City of Ryde Submission

IVANHOE ESTATE REDEVELOPMENT - STAGE 3

SSD-30530150

Council reference: COR2022/87
Submission Date: 26 July 2023

Figure 43 Proposed setbacks outlining the range and breaches of setbacks

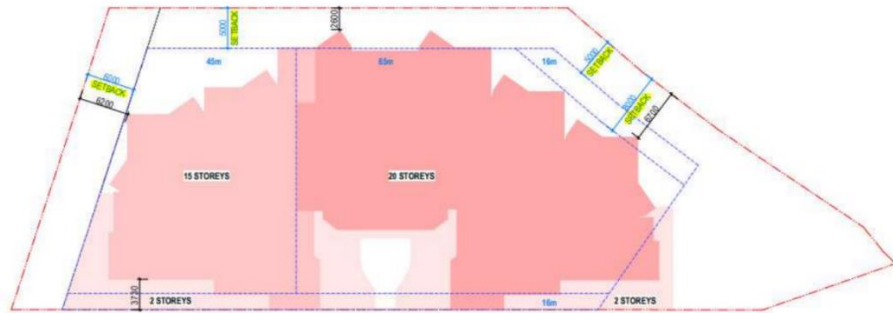
- i. **Front Setback.** The proposed 100mm setback along the main street detracts from the general streetscape requirements along Type 1 road in Macquarie Park. The proposal is also inconsistent with the general setback provided by Stage 2 Buildings located opposite the site. The setback is also inconsistent with the setback provision under the Concept Plan.

As the building is significantly tall, and the upper floors are almost proposed on the front boundary, it results in a high degree of visual sensitivity due to the overwhelming mass presented closer to the main road and building/park opposite the site.

Council requests that a clear setback of at least 2.5m be provided along the main street on all levels instead of the proposed 100mm. The loading dock (turntable) and the apartments on levels above must be setback further to achieve the required setback.

4.4 Test Method – Sensor Locations

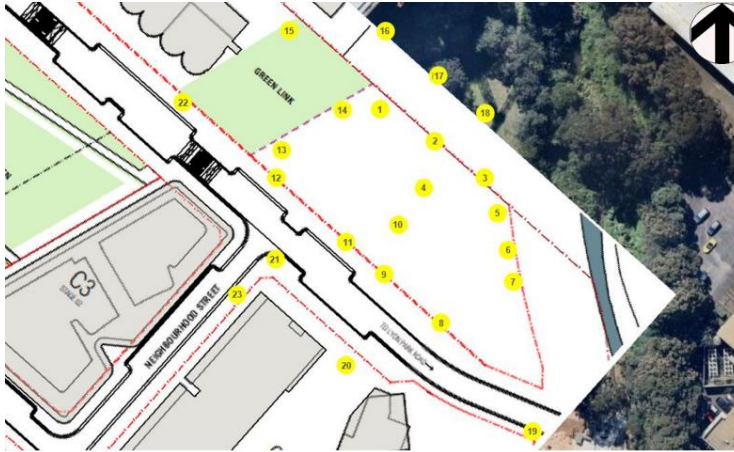
In addition, it is unclear if the Wind Impact assessment has considered the wind impact to the proposed recreation area at Shrimpton creek and skate park. In review of the assessment, it appears to not have contemplated wind impact at the skate park, and has suggested it is not considered due to setbacks. See below quote from Wind Impact Assessment:

Wind Sensors and an assessment of impacts should have been considered from the proposed public domain. This is particularly important, as the public domain will not achieve its intended purpose if it is too windy for comfortable usage from Community members, therefore being counterproductive from its intended purpose.

Council requests that the wind impact assessment be revised to consider such impacts.

Enhanced version of GFA Schedule showing level 14 – communal open space not included in FSR.

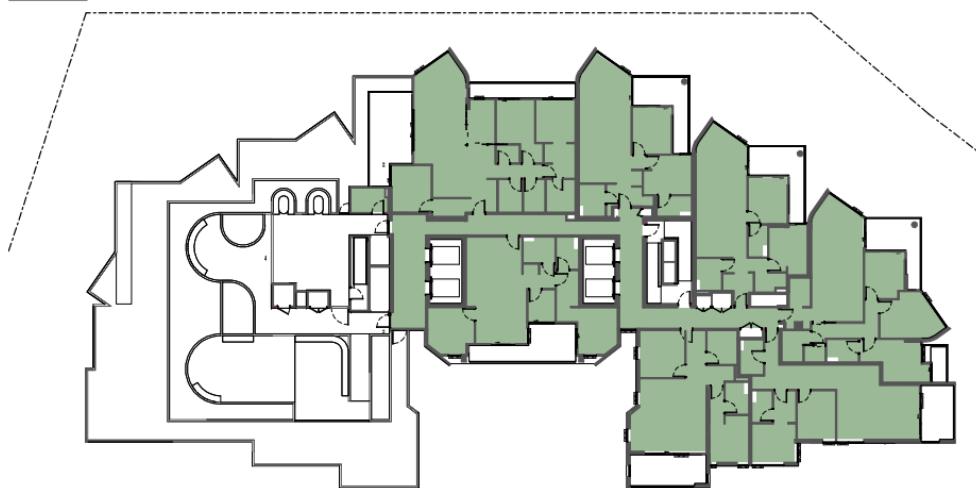
- As per the above, even at 1.5m high the wind shielding is to be counted as FSR. The Applicant's FSR schedule has not counted the 1.5m shielding as FSR. The applicant needs to recalculate their FSR schedule. See below extract.

Figure 20 Balcony Wind Shielding Recommendations from Level 3 and up (L3-13 representative plan shown)

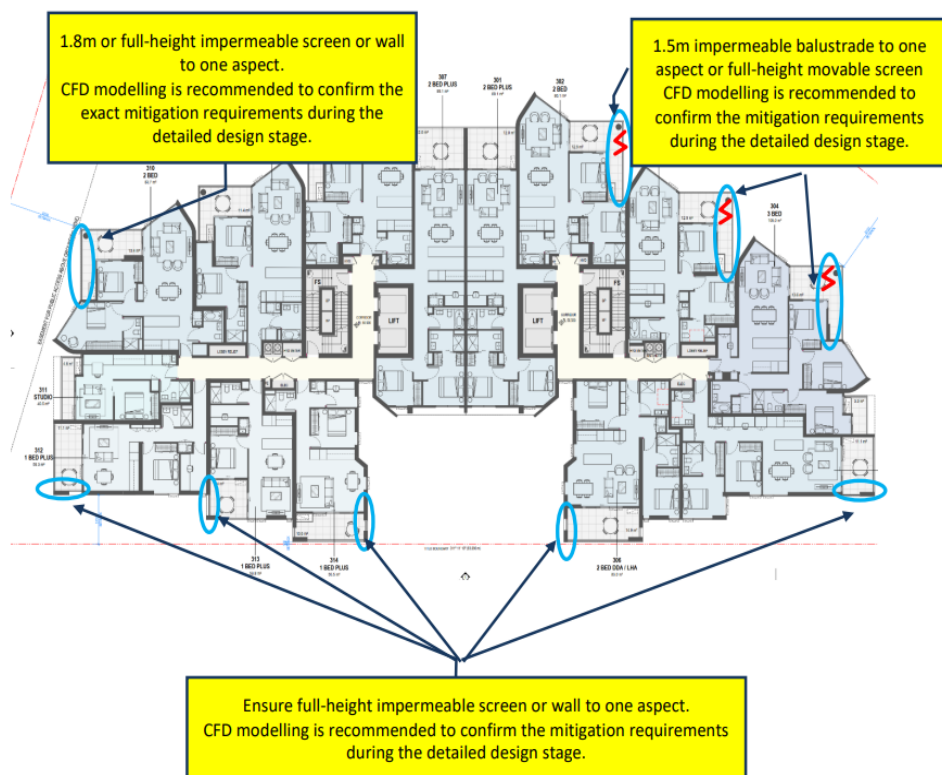
- Furthermore, it is noted that from levels 3-13 (and measures above level 14 – to level 20) additional wind impact measures are proposed in the wind impact assessment, however these recommendations have not been drawn/carried over onto the architectural plans. Please refer to the below figure:
- The recommendation included depending on façade aspect that that:
 - 1.8m Impermeable screening
 - 1.5m Impermeable screening
 - Full height Impermeable screening
- The above recommendations need to be shown on the plans. This in turn may add additional GFA to the design which has not been calculated in their FSR plan. Please refer to the below figure:

- Council's position is that it is unreasonable to not include these design recommendations and they should be imposed to ensure that residential amenity is preserved for future occupants.

FSR extract from applicants plans – showing balcony areas not as FSR

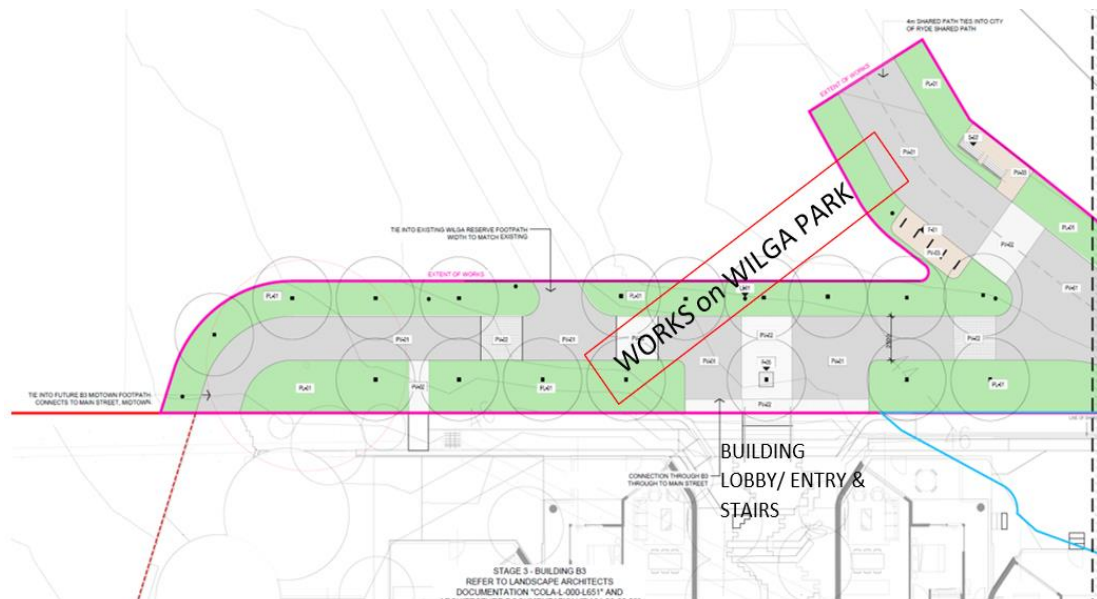
Whilst it is unclear the amount of missed GFA the Applicant has omitted from their package due to not including areas Council identified as GFA, it becomes apparent that if all wind measures are implemented in the design, this additional area may increase the maximum amount of FSR permitted on the site via the concept approval. Given the above, the Applicant is to recalculate their GFA associated with the scheme.
